Piping Layout Drawings

As referenced in Section B – Site Information, FDEP Comment 1

Revised Figure 1 (Renamed as Figure 2)

Revised Secondary Tank Calculations

APPROVED		PLANT BARTOW	PIPING BLEND PLANT TANK FARM & PIPE RACK PLAN
BY	DATE	UNIT-BLOG.	
EE BARNARD	5-8-88	AFE	SCALE: 1" = 10'
RA-4	5-8-88	36045	
WALLACE	6-17-88	DRAWN SHERLOCK	
WALLACE	6-17-88	DATE 4-7-86	
WALLACE	7-26-88		DRAWING NO. 3363-PD-101
			REV 2

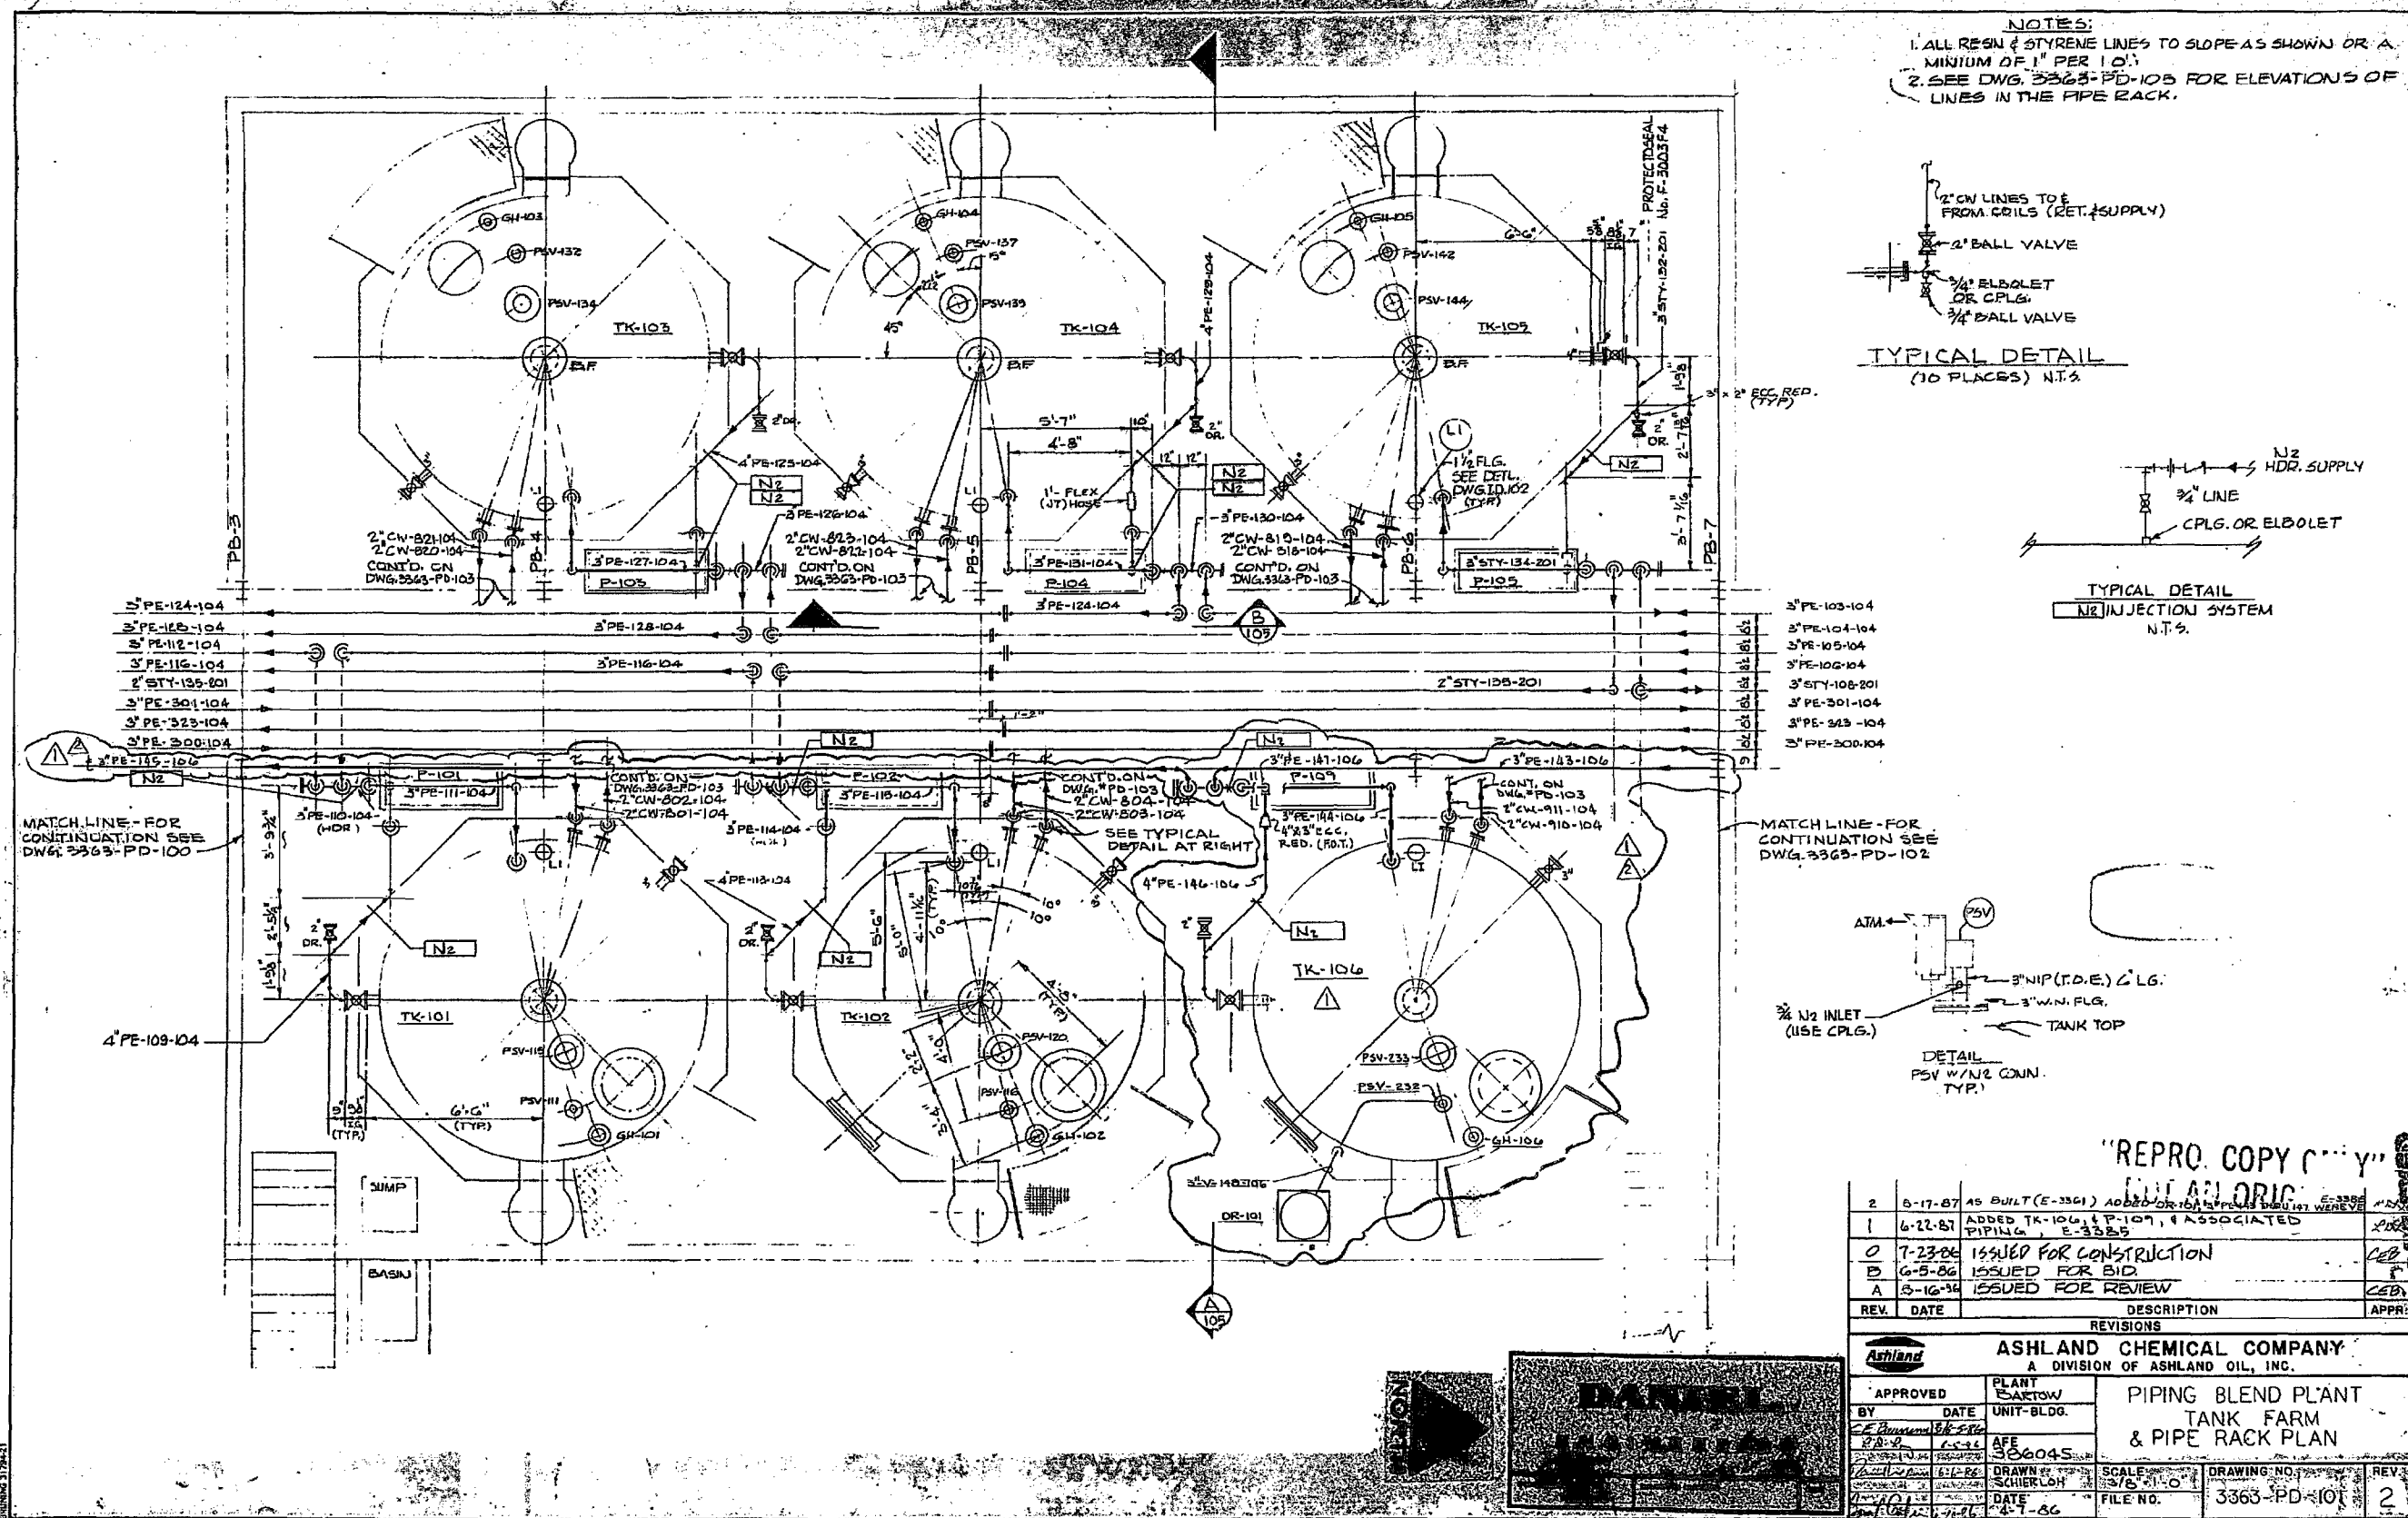
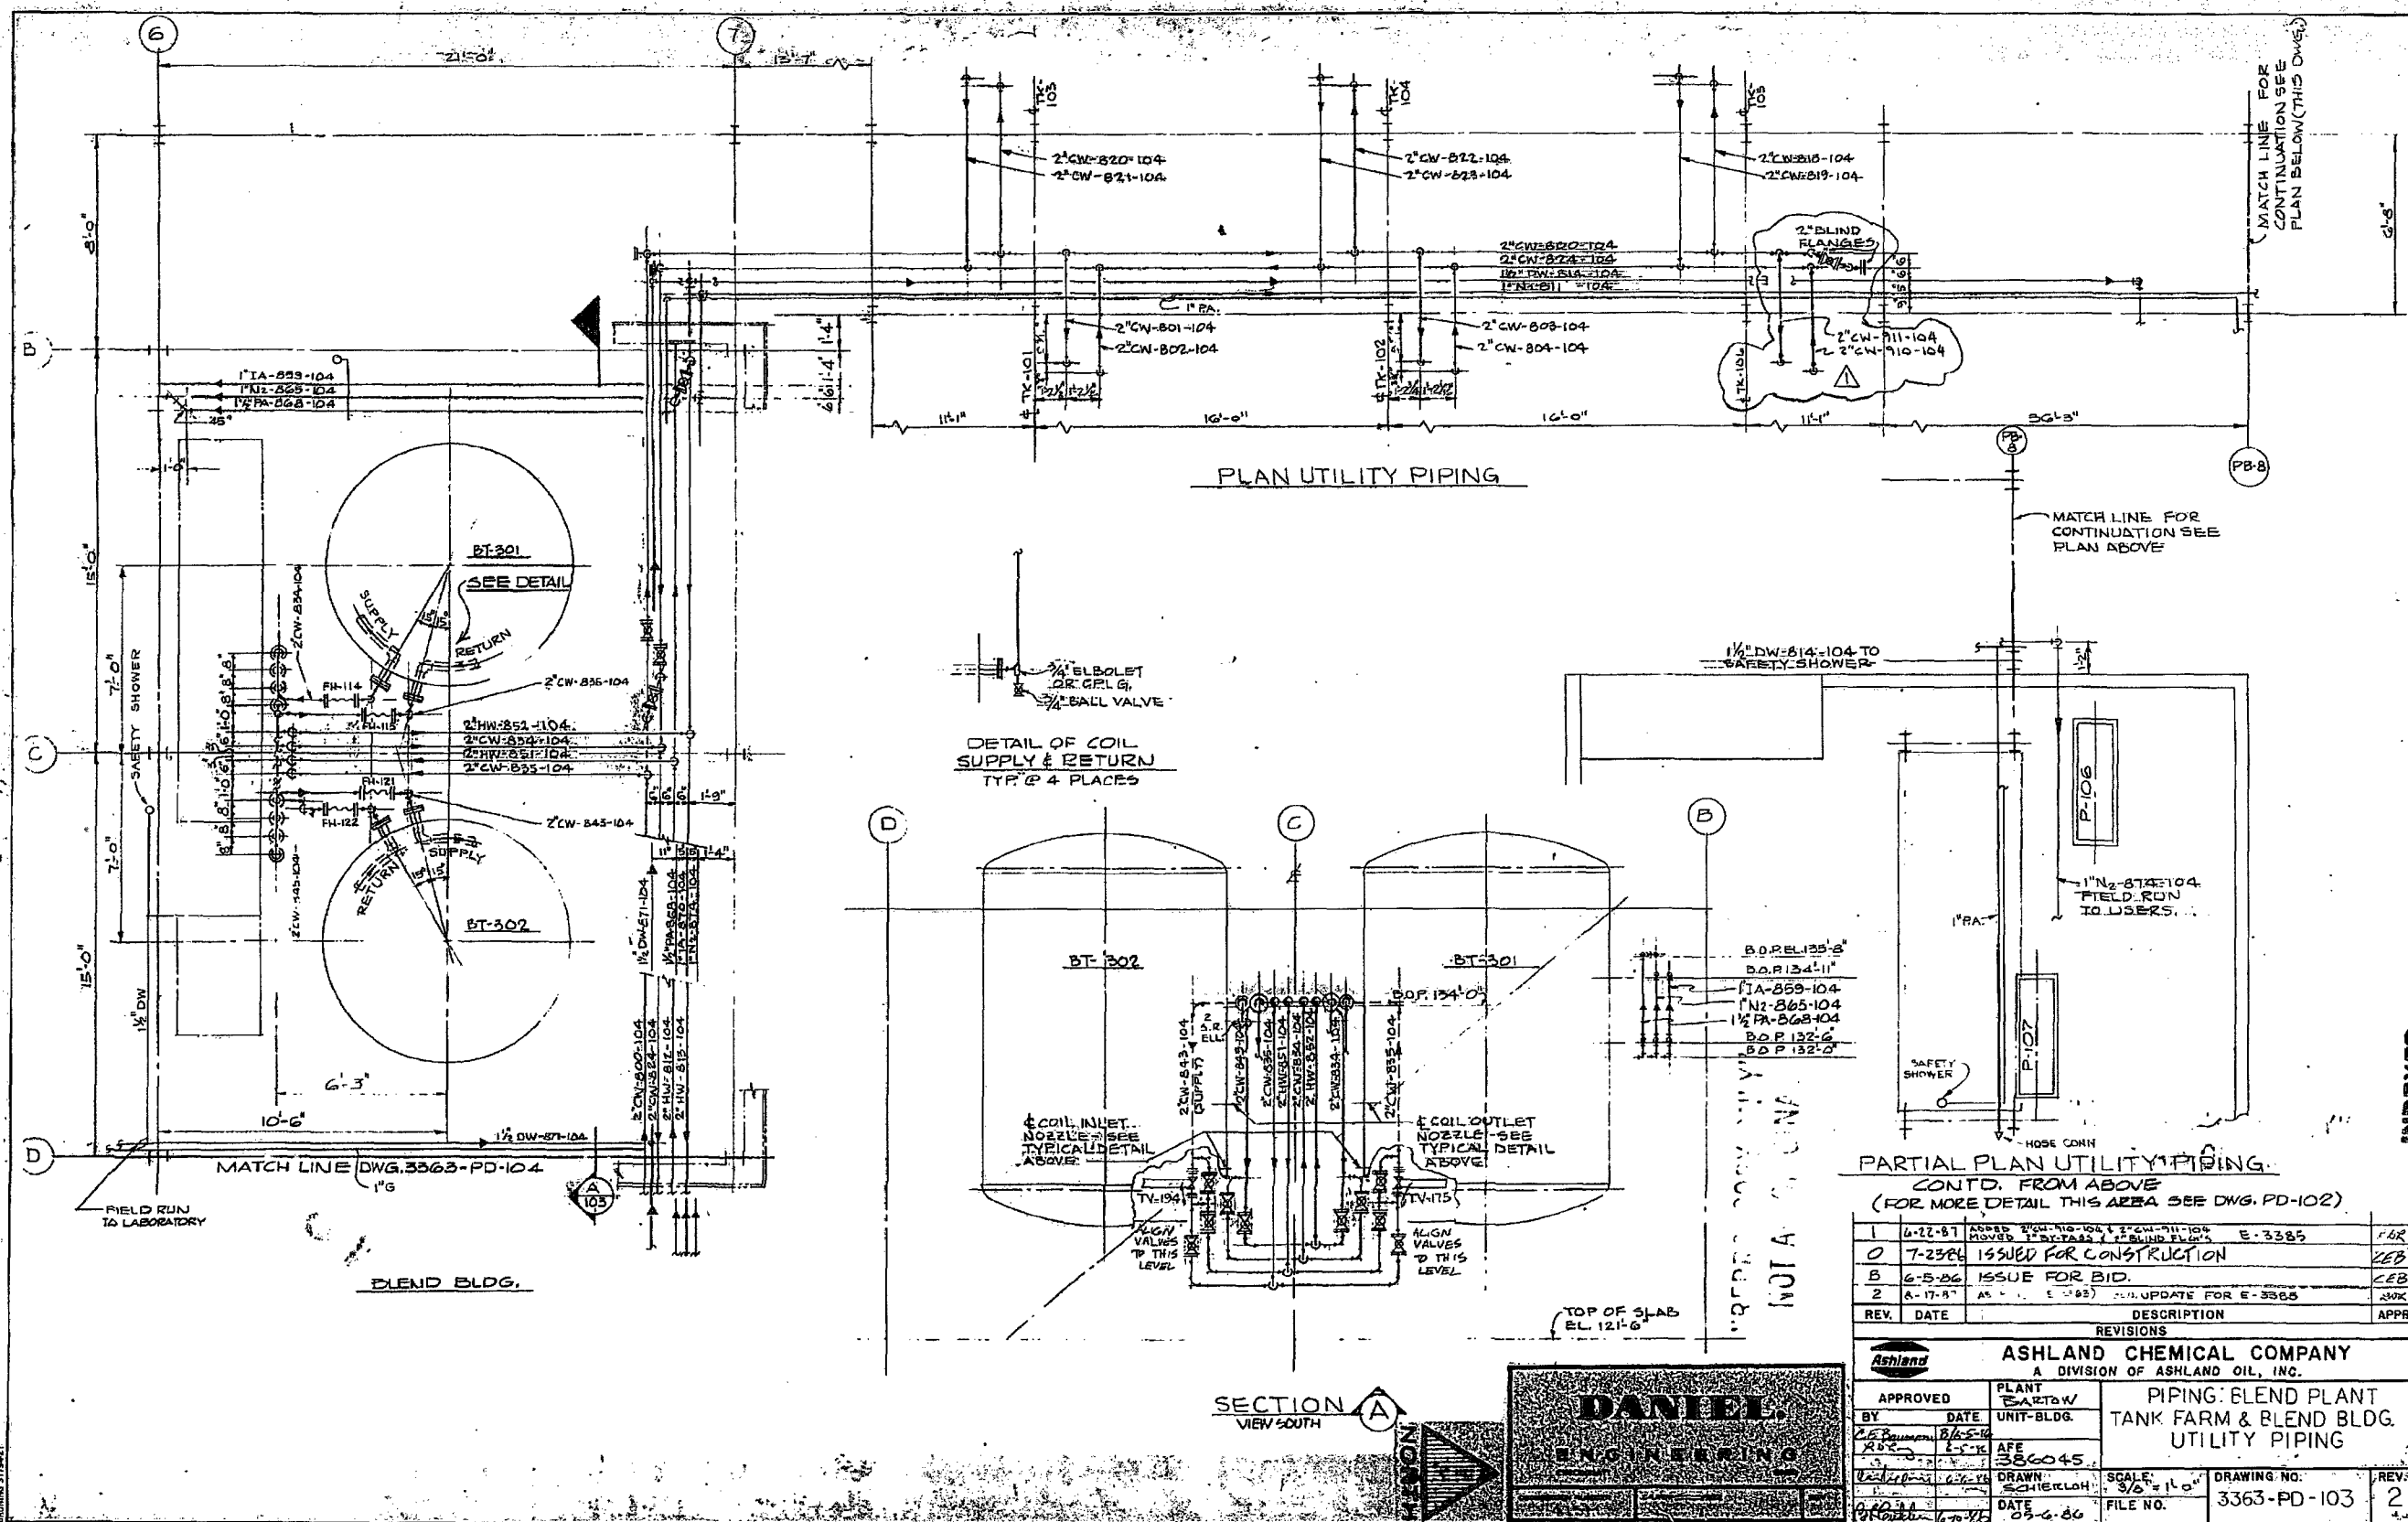
Section C – Operational Information, FDEP Comment 9

Figure 2
 Facility Site Layout

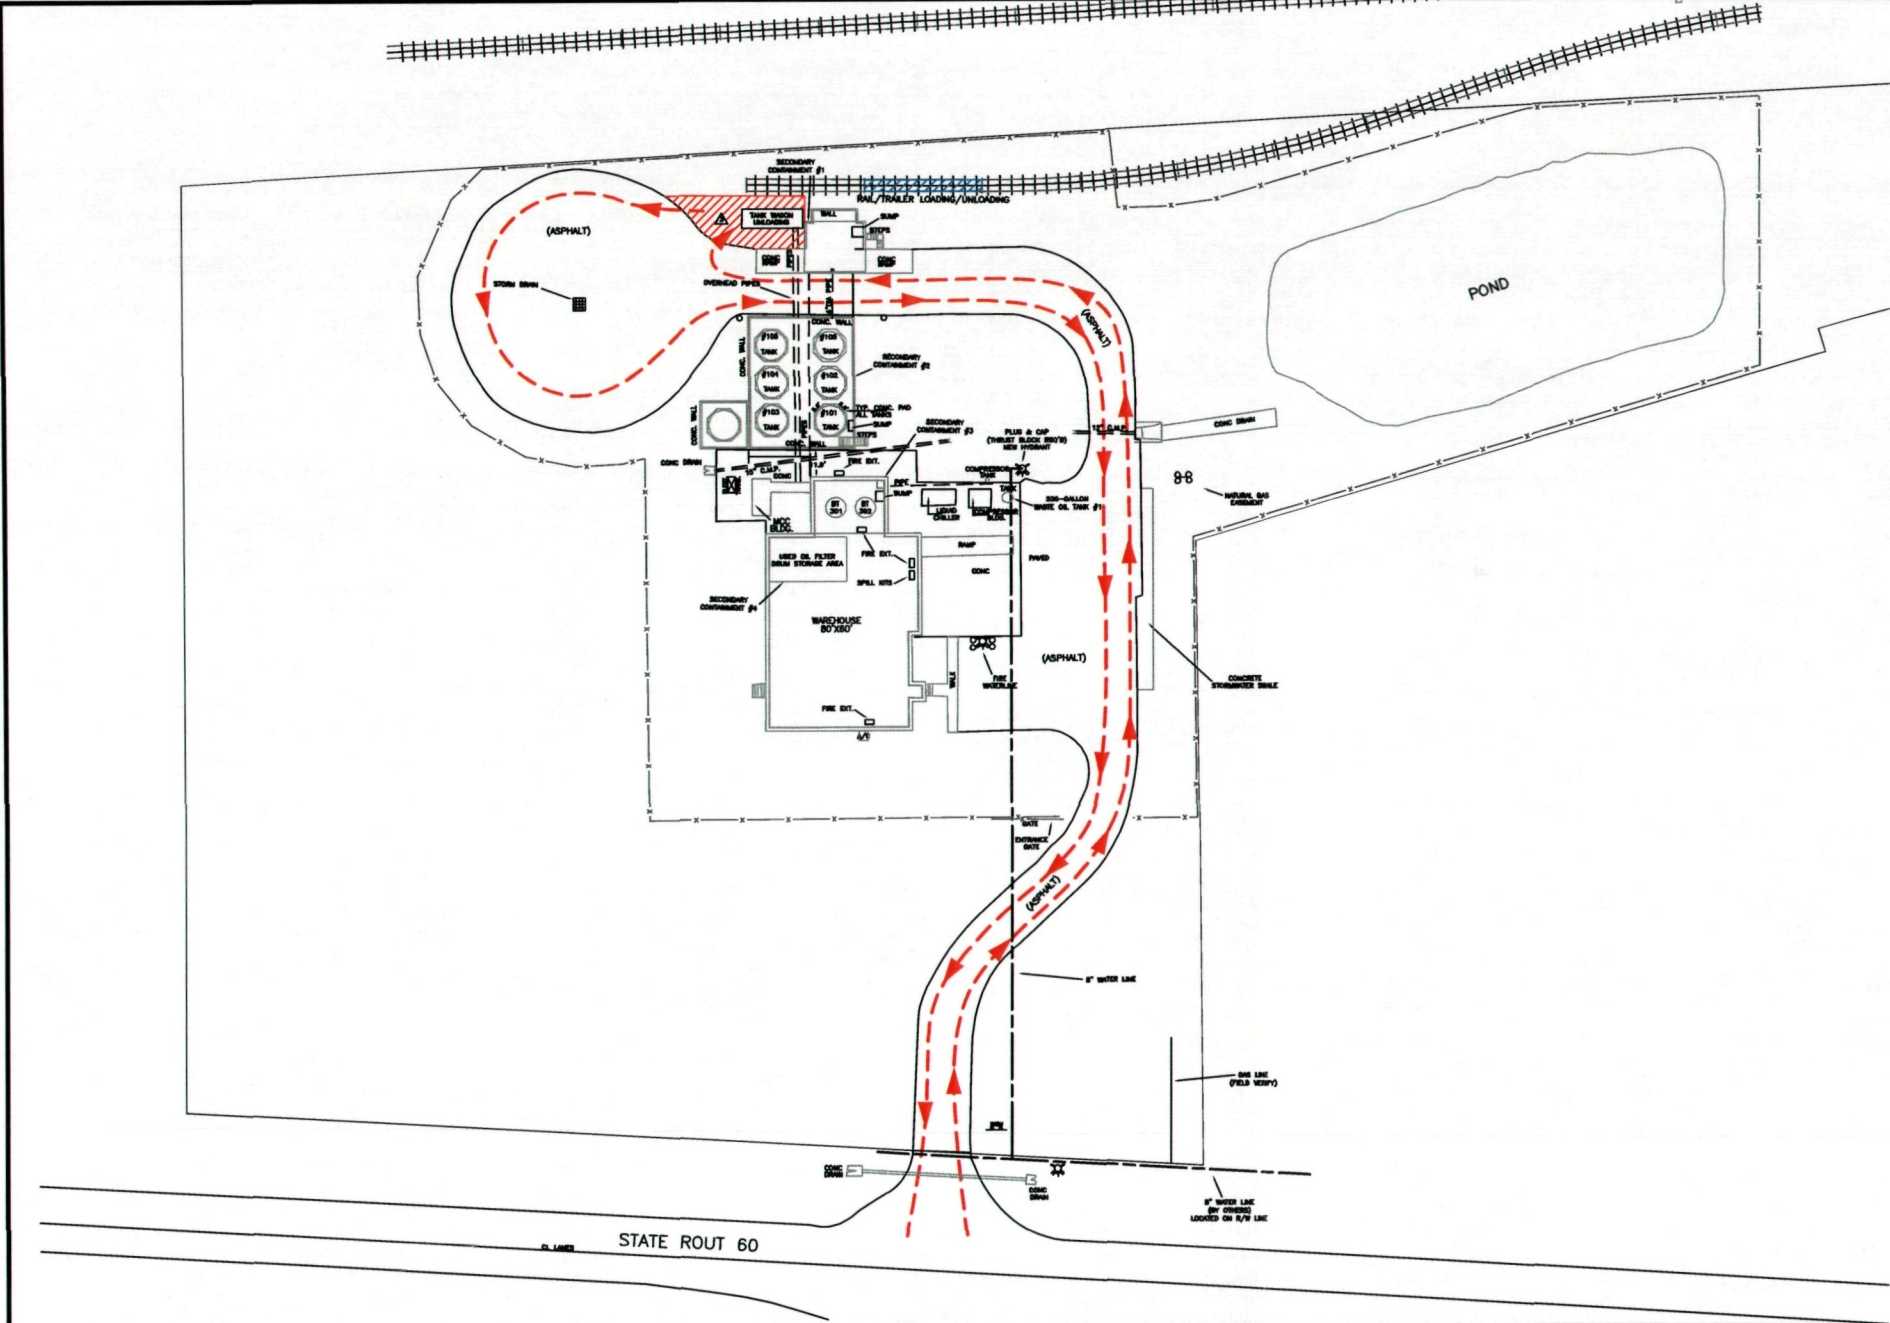
As referenced in Section B – Site Information, FDEP Comment 2
